UMC 817.44 - HYDROLOGIC BALANCE : STREAM CHANNEL DIVERSIONS

3/99 Addendum - North Diversion Channel Hydraulic Capacity Characteristics

APPENDIX TO UMC 817.44

RE: **J.B. KING**  
 CAPACITY OF CLEANED NORTH DIVERSION CHANNEL

North Diversion Ditch  
J.B. King mine  
Tributary Area

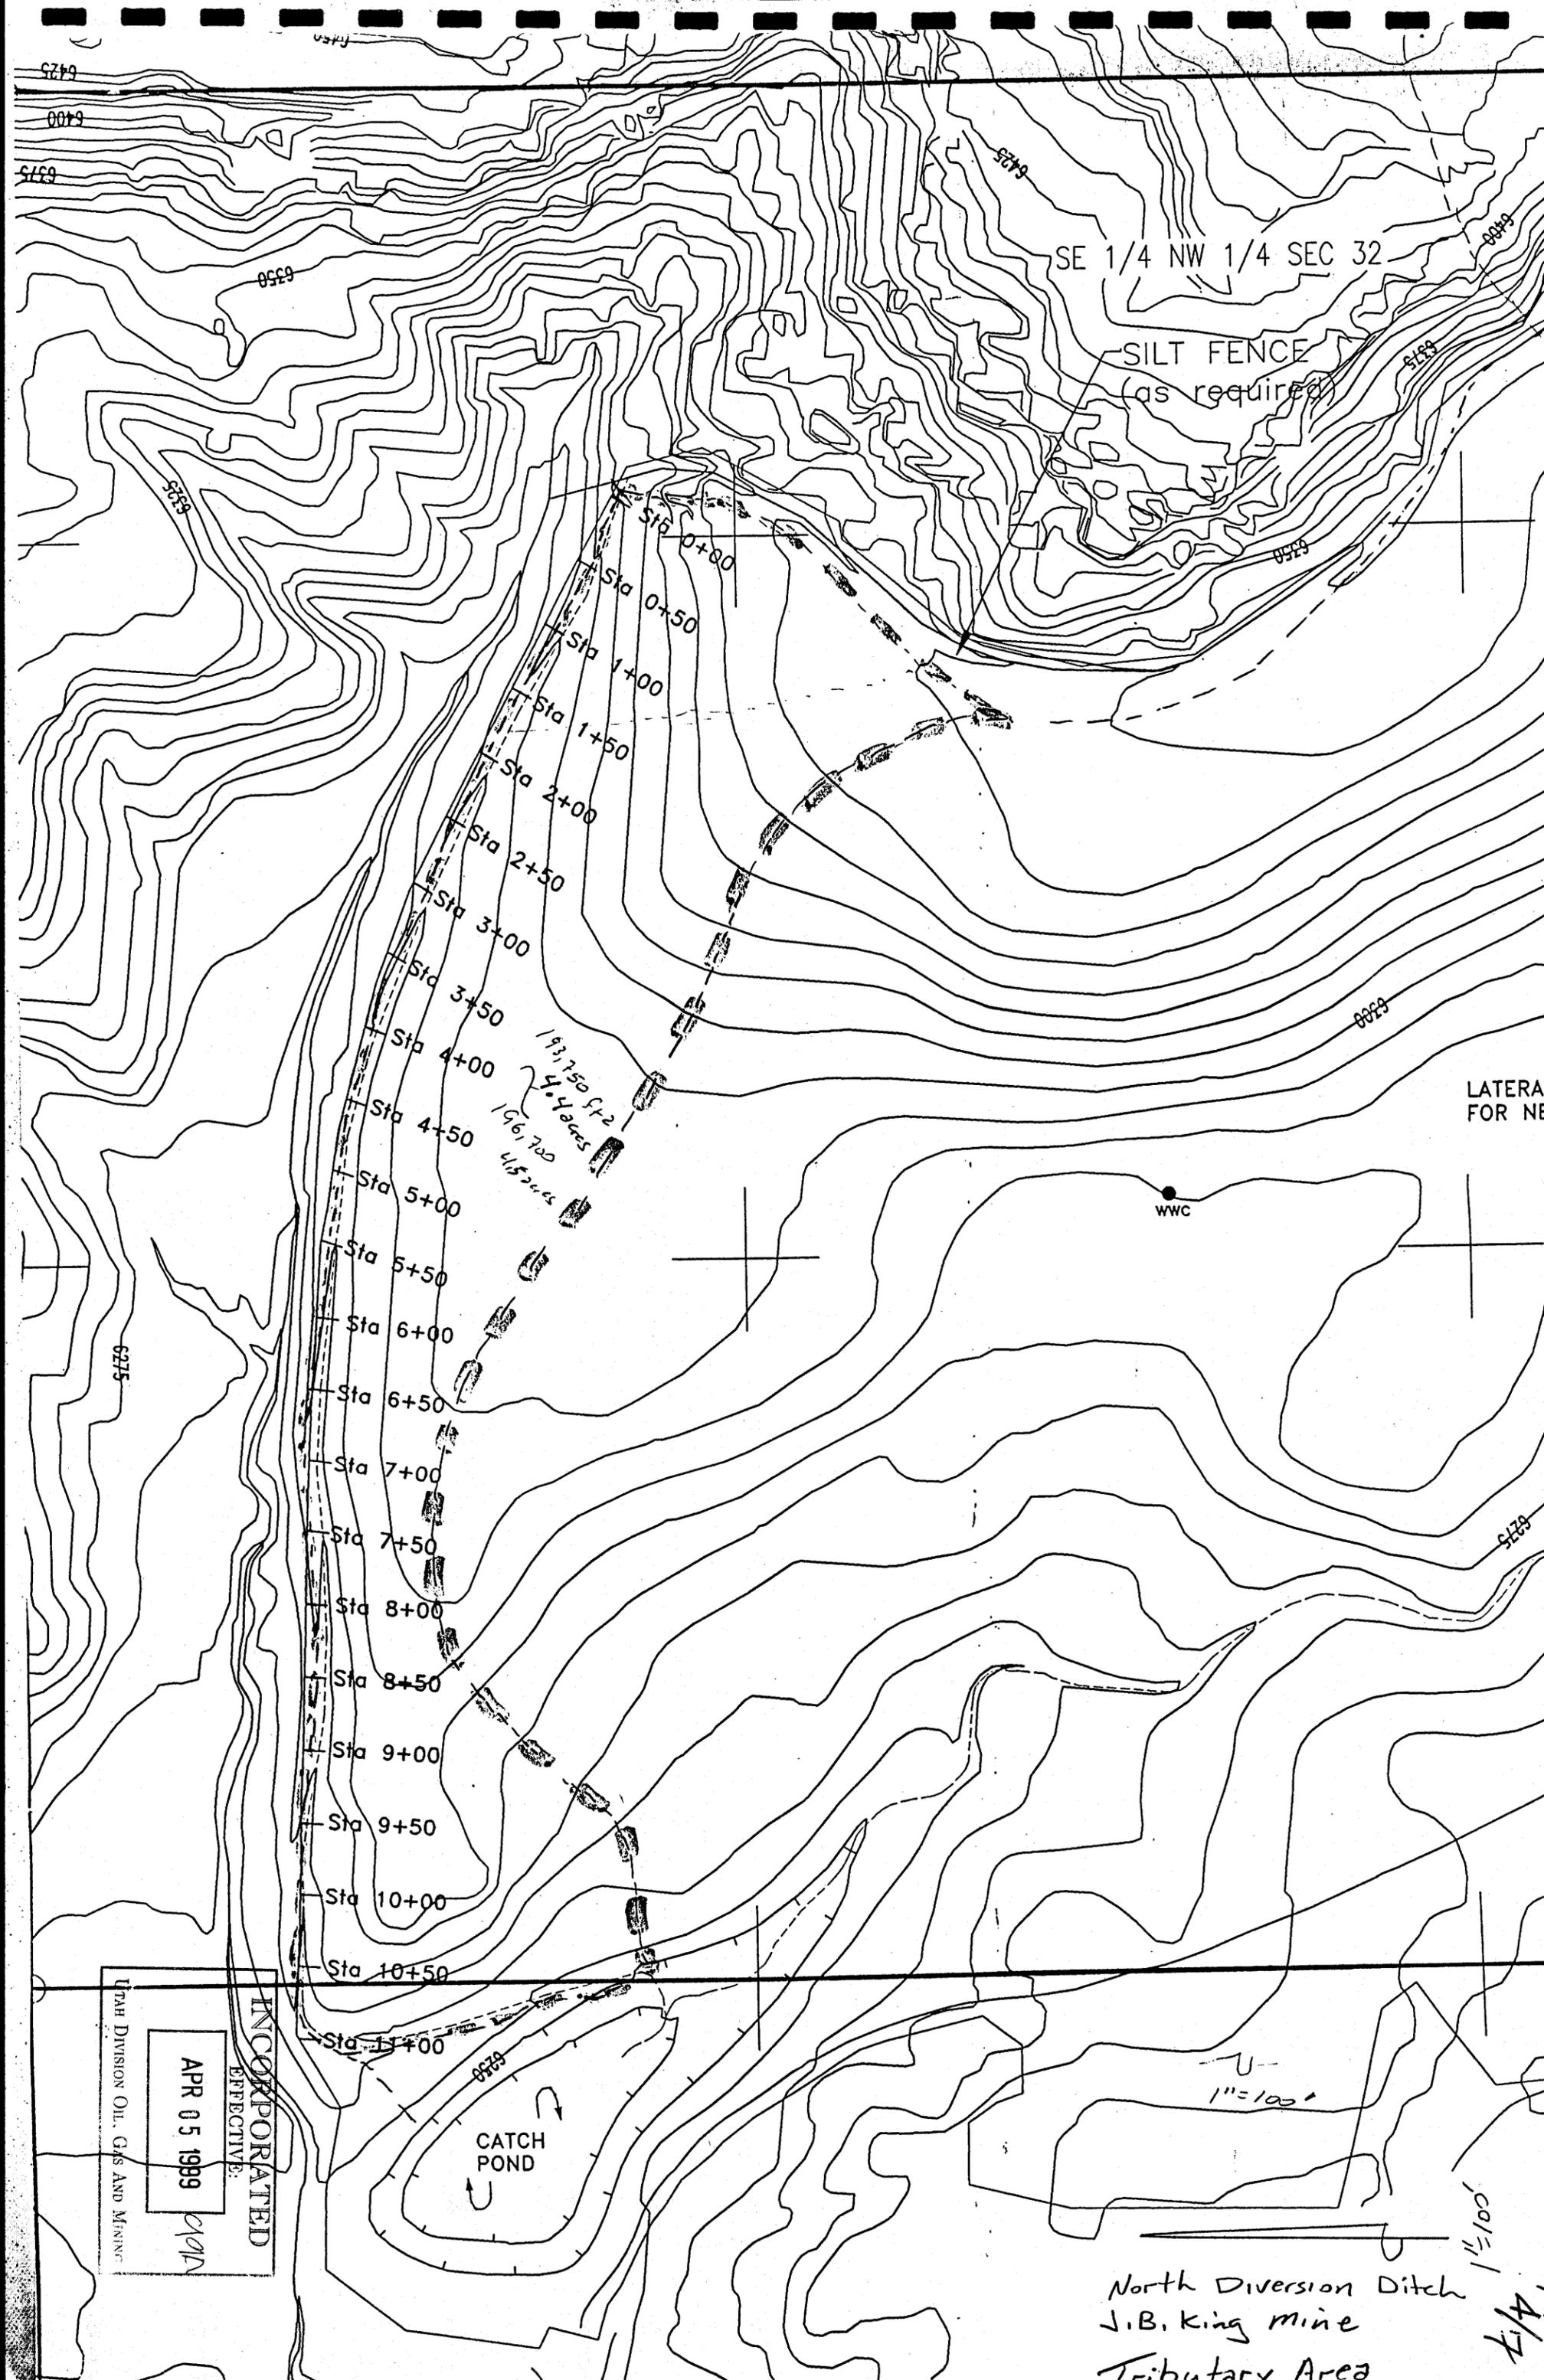
Please review the accompanying map **JBK-4 As Built** for the general location of the North Diversion channel. The engineering firm of Hansen, Allen & Luce Inc. has analyzed the "as built" information of the cleaned out ditch and determined that this ditch has ample capacity for a 10 year storm event. This analysis is attached (*Appendix to UMC 817.44*) as a permanent part of the design characteristics for incorporation into the permit.

**3/99 Addendum #1 – North Diversion Channel** - This internal drainage channel intercepts surface overland flow within the disturbed area boundary, and directs that flow to the sedimentation impoundment. Since its inception in 1985-86 it has functioned properly and without incident. However, it became silted in prior to the fall of 1998 and a significant precipitation event caused the channel to breach and the flow to escape outside the disturbed area boundary. This was the basis of the issuance of NOV# N98-45-4-1. This has been terminated with clean-out work performed in Nov. 1998, and should remain fully functional for the remainder of its useful life.

**3/99 Addendum #2 – Silt Fence Removal** - An approximate 50 to 75 ft. section of silt fencing along the northeast boundary of the disturbed area, between the reclaimed vegetation test plot area and the diverted undisturbed surface drainage, was removed in Nov. 1998. This specific area no longer required silt fence protection; since the soils were stabilized through revegetation and natural rock armoring.

**3/99 Addendum #3 - Husbandry Practices** - Husbandry practices were incorporated into an approximate 0.67 acre parcel, located in the north-central portion of the disturbed area boundary; and directly south of the North Diversion Channel. During the Nov. 1998 site work plan, this area had the ground “roughened” using a hydraulic excavator and reseeded with the approved seed mix.

*Note- All of the above listed addenda are shown on the attached map JBK-4 AS BUILT*
